PROJECT NAME
**CHILDREN'S HOSPITAL
OF ORANGE COUNTY**
455 S. Main St.
Orange, CA 92668-3874

TOWER II

DRAWING TITLE
LEVEL 1 FLOOR PLAN

A3.11

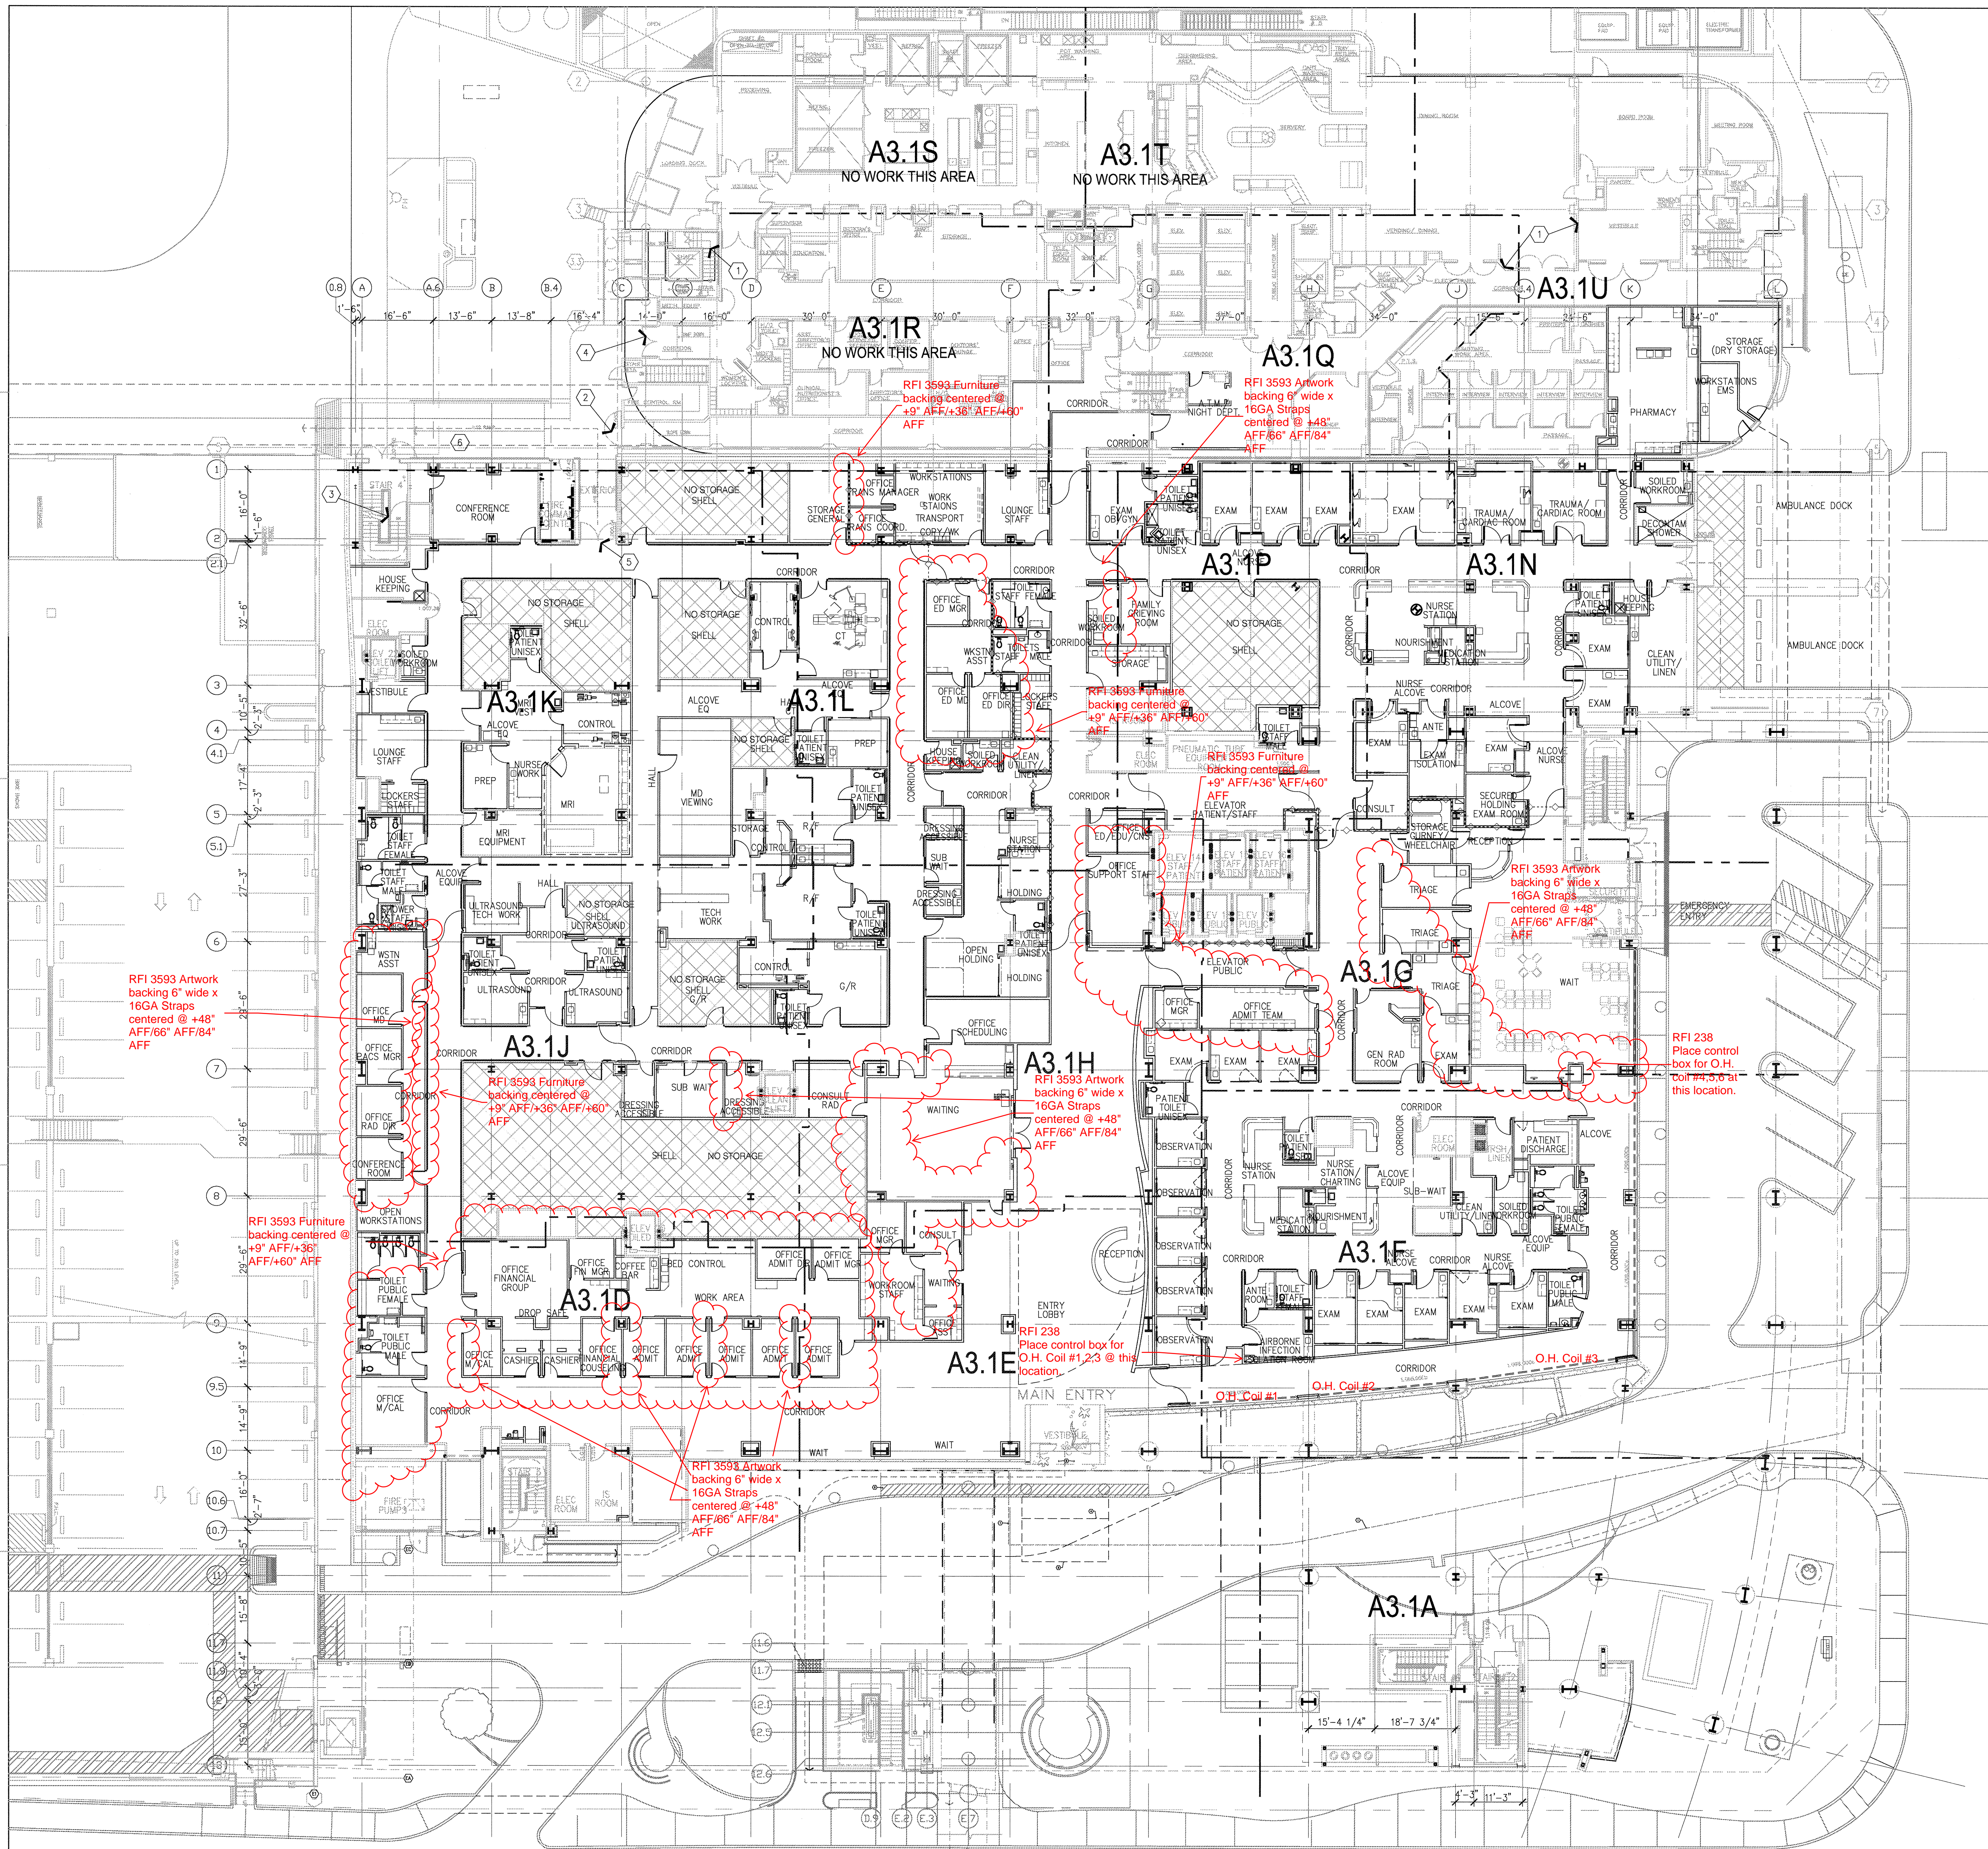
RFI 4137
Life Safety Approval in
ED Remodel Area

RFI 3593 Artwork
backing 6" wide x
16GA Straps
centered @ +48"
AFF/66" AFF/84"
AFF

RFI 3593 Furniture
backing centered @
+9" AFF/36" AFF/60"
AFF

RFI 3593 Artwork
backing 6" wide x
16GA Straps
centered @ +48"
AFF/66" AFF/84"
AFF

RFI 3593 Artwork
backing 6" wide x
16GA Straps
centered @ +48"
AFF/66" AFF/84"
AFF

RFI 3593 Furniture
backing centered @
+9" AFF/36" AFF/60"
AFF

RFI 3593 Furniture
backing centered @
+9" AFF/36" AFF/60"
AFF

RFI 3593 Artwork
backing 6" wide x
16GA Straps
centered @ +48"
AFF/66" AFF/84"
AFF

RFI 238
Place control box for O.H.
Coil #1, 2, 3 @ this location.
